Access Compliance Report

Public Rights-of-Way (Curb Ramps)

Intersection ID: 11231	Main Street: W_4TH_ST_EXT	Cross Street: WALNUT_AV	Location:	N
ADA ID: 994DFE13A0DC	Ramp Type: Directional1	Initial Pass/Fail: Pass	Overall Compliance: No	Severity Score: 0.25
Codes/Mitigation Info/Possible Solution		Field Measurements/Component Compliance

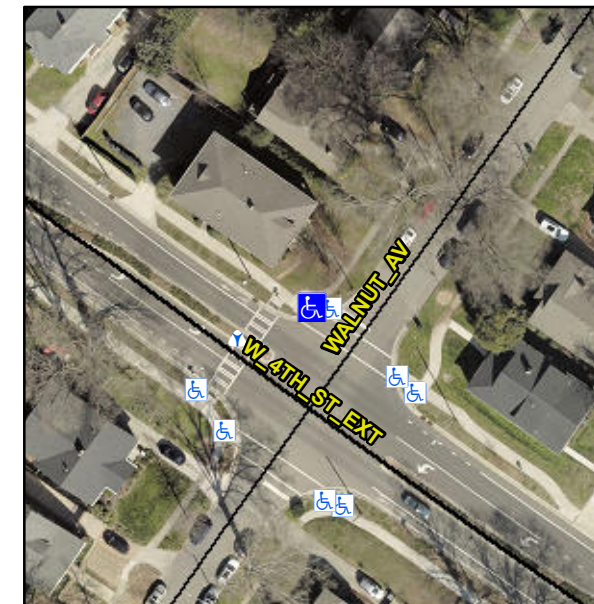
R304.5.3, R304.5.2

Compliance	Description	Data	Compliance	Description	Data
N/A	Ramp Length (in)	65.0	No	Grade Break?	No
Yes	Ramp Width (in)	73.0	N/A	Grade Break Slope (%)	N/A
Yes	Ramp Slope (%)	7.1	N/A	Grade Break XSlope (%)	N/A
No	Ramp XSlope (%)	3.0			
Yes	Flare Type LT	N/A	Yes	Flare Type RT	N/A
N/A	Flare Slope LT (%)	N/A	N/A	Flare Slope RT (%)	N/A
N/A	Flare Traversable LT?	No	N/A	Flare Traversable RT?	No
Yes	Landing Length (in)	71.0	Yes	DWS Provided?	Yes
Yes	Landing Width (in)	70.0	Yes	DWS Contrast?	Yes
Yes	Landing Slope (%)	1.1	Yes	DWS Length (in)	24.0
No	Landing X Slope (%)	3.6	Yes	DWS Full Width?	Yes
N/A	Landing Curb? (Y/N)	No	Yes	DWS Offset LT (in)	12.0
N/A	Shared Landing?	No	Yes	DWS Offset RT (in)	0.0
Yes	Gutter Ponding?	No	Yes	Gutter Slope (%)	3.1
Yes	Gutter Lip Ht (in)	0.0	No	Gutter X Slope (%)	2.9
N/A	Painted X Walk1?	No		Road Slope (%)	2.5
	X Walk 1 Direction	To SW		Road X Slope (%)	2.6
	X Walk 1 Width (in)	N/A		Clear Space?	Yes

**Remove & Replace Entire Ramp.
Remove & Replace Gutter.**
